City of Portland, Oregon
Bureau of Development Services
Land Use Services
FROM CONCEPT TO CONSTRUCTION

MEMORANDUM

Date: September 5, 2018
To: Phil Beyl & Jesse Emory, GBD ARCHITECTS
From: Benjamin Nielsen, Senior City Planner
Benjamin.Nielsen@portlandoregon.gov, 503-823-7812
Re: 18-159309 DA – Block 216
Design Advice Request Summary Memo August 16, 2018

This memo summarizes **Design Commission** design direction provided on August 16, 2018.

FLOOR PLAN | LEVEL 01

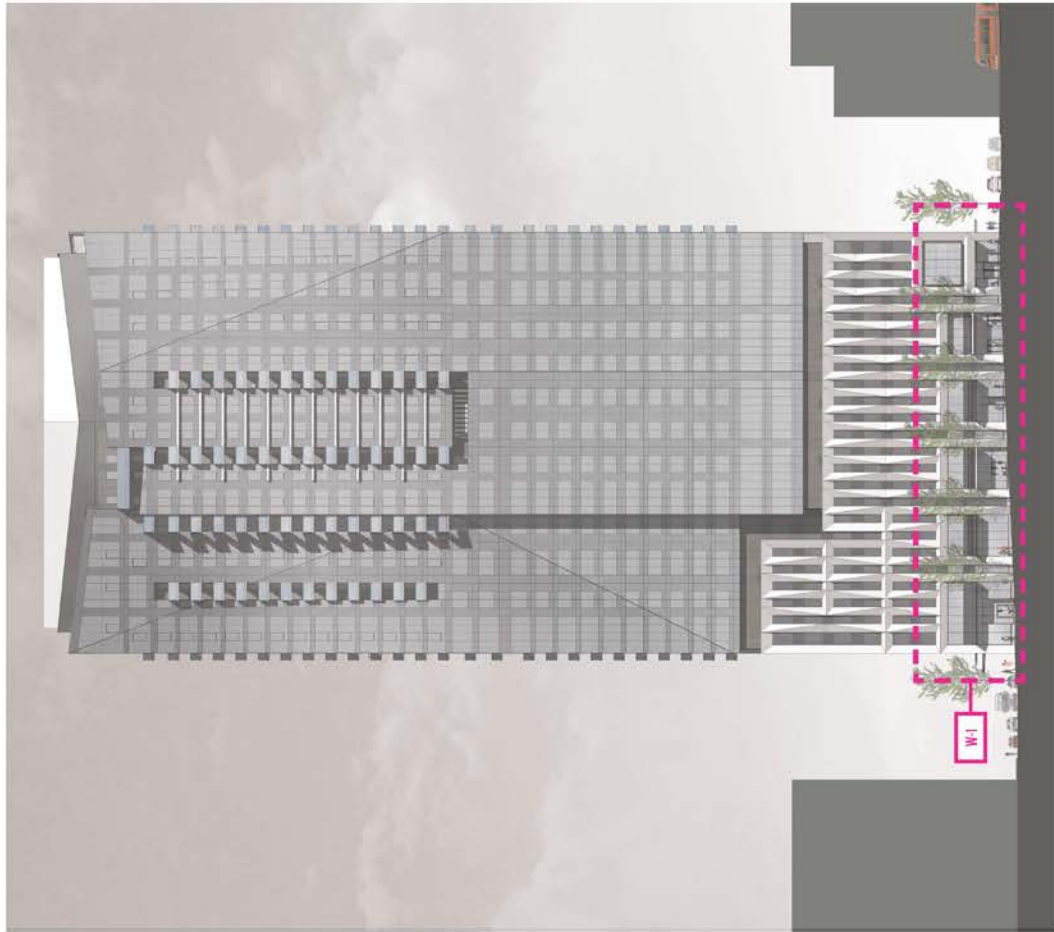
- Nearly all commissioners stated that the proposed hotel drop-off area will not meet design guidelines that strive for an active streetscape with flexible-use spaces, and that it should be internalized. They also stated that it would not successfully meet guidelines B1 – Reinforce and Enhance the Pedestrian System and B2 – Protect the Pedestrian. One stated, “the more area given to auto activities, the more harm that does to that side of the street.”

- The ground floor response to guideline B4 – Provide Stopping and Viewing Places needs more development.
- Some commissioners questioned the placement of numerous large vents along the sidewalk as well as the large gas meter area next to the large loading area. They expressed concerns about the human experience of walking past metal vents as opposed to windows or building material and stated that vents, louvers, and grilles should not be expressed where they are not needed.

- Commissioners also pointed out a somewhat minor comment regarding the fire command room, stating that it should be moved off of the exterior face of the building.

WEST ELEVATION

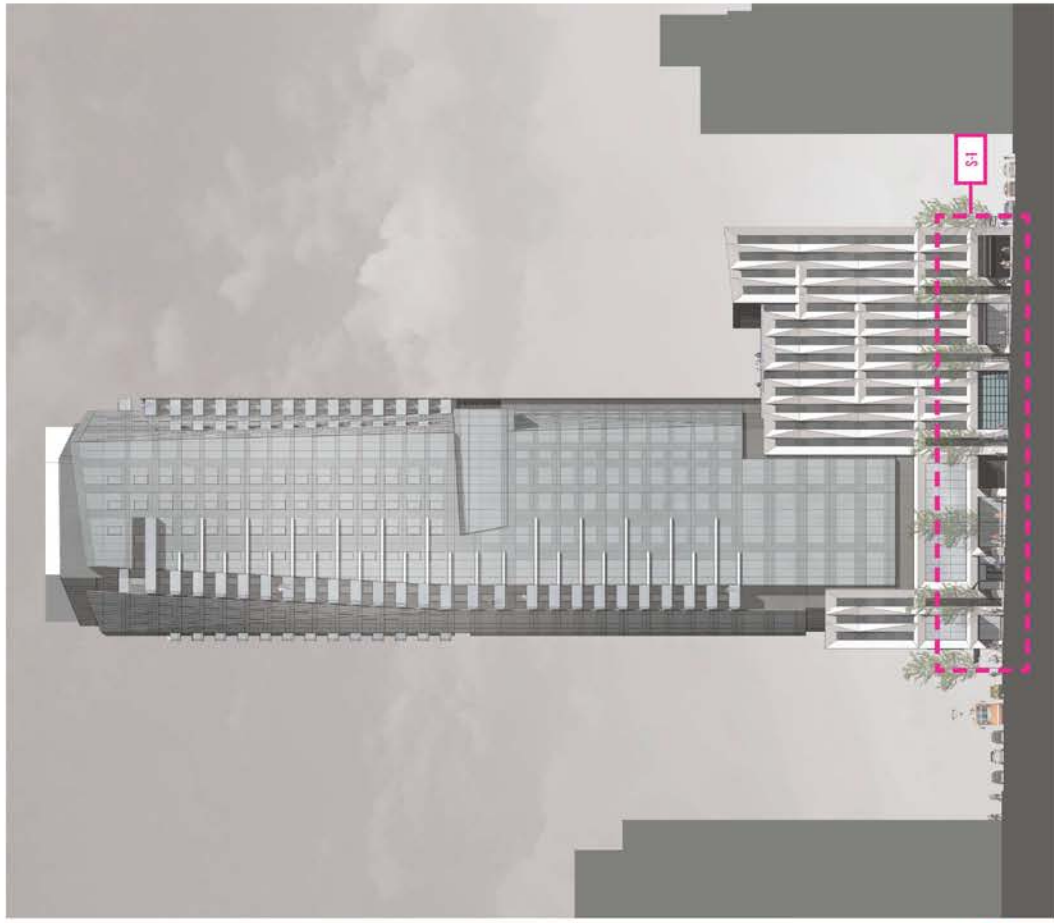
- One commissioner noted that the pilaster expression of the east and west elevations becomes diluted on the south and, particularly, north elevations. This causes the podium to lose its strength and dilutes the distinction between the tower and the podium.

SOUTH ELEVATION

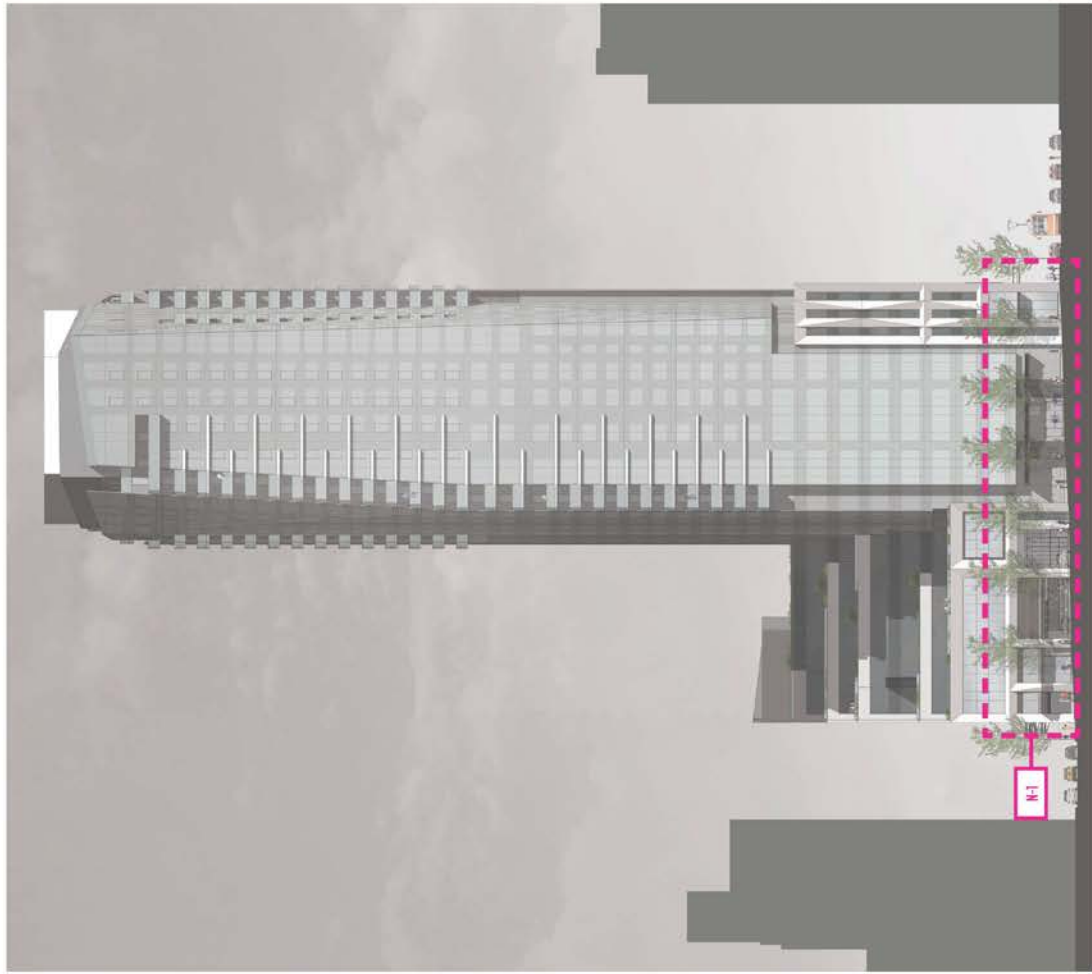
- Some commissioners expressed concerns that the north and south facades were the least successful, particularly at the ground level, and that in light of the modification request to the setback along SW 9th, these needed an extra effort to be more consistent with the guidelines.
